Elevation Plans_V1.pdf Markup Summary

6/27/2022 9:39:02 PM (1)

4 SIDE ELEVATION (NORTH-EAST)
 SCALE: 3/16" = 1'-0"

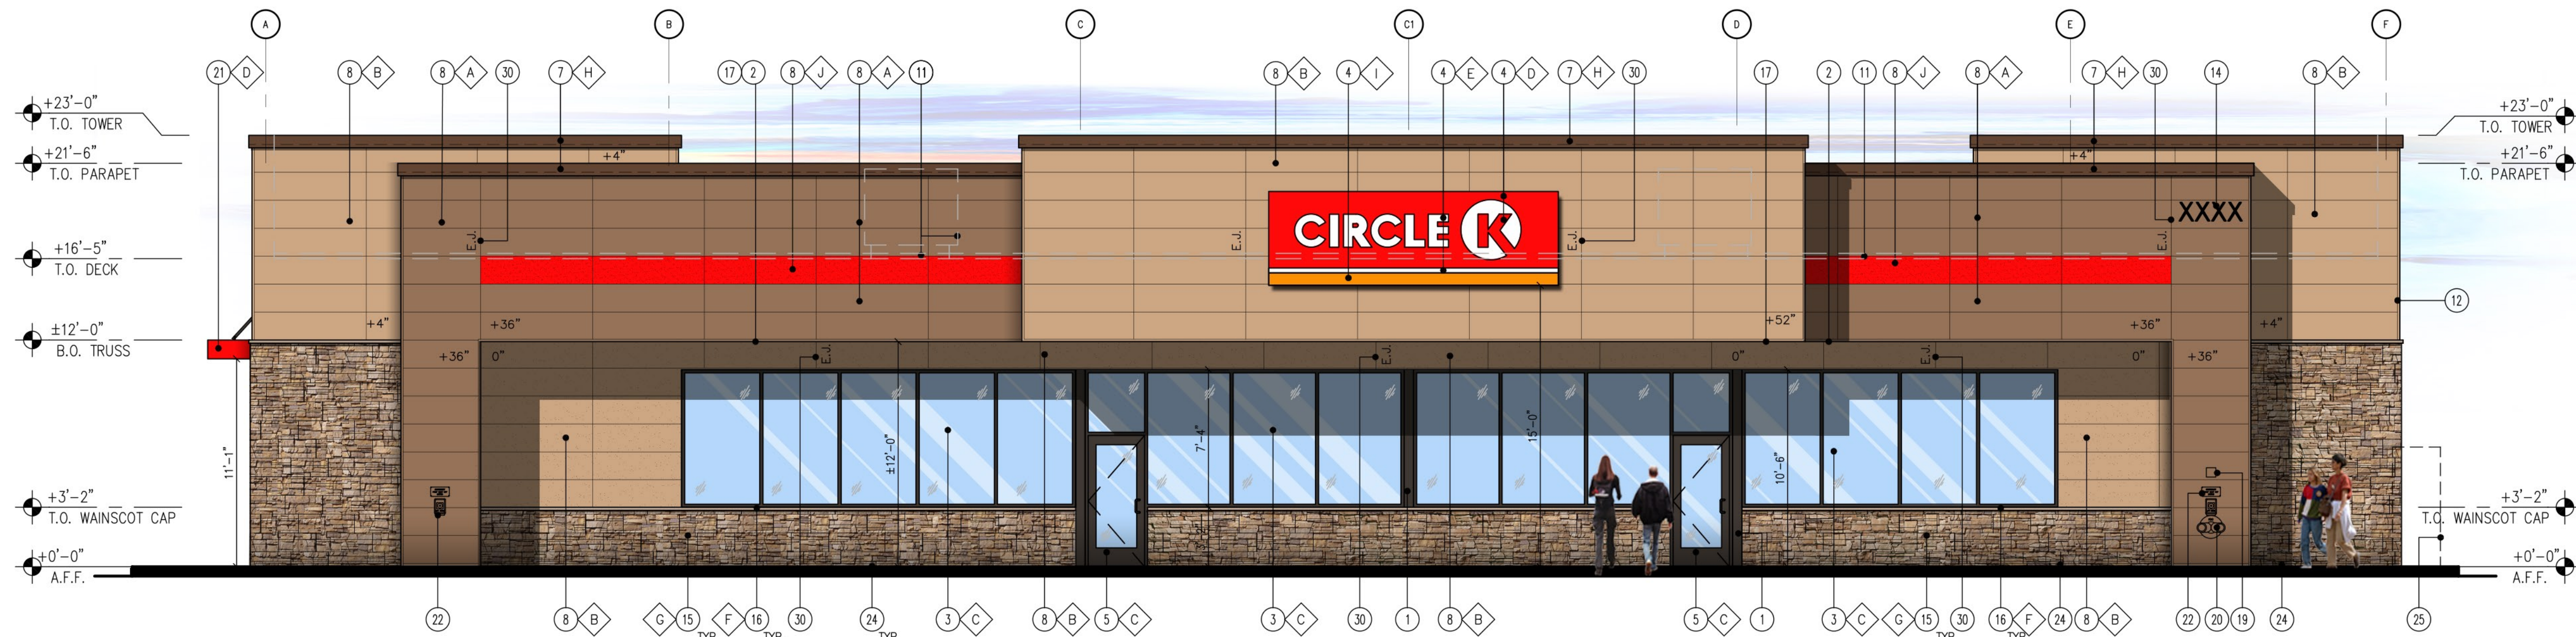
Include Signature block for the Planning and Community Development Director a minimum of 1 inch by 2 inch.

Include Signature block for the Planning and Community Development Director a minimum of 1 inch by 2 inch.
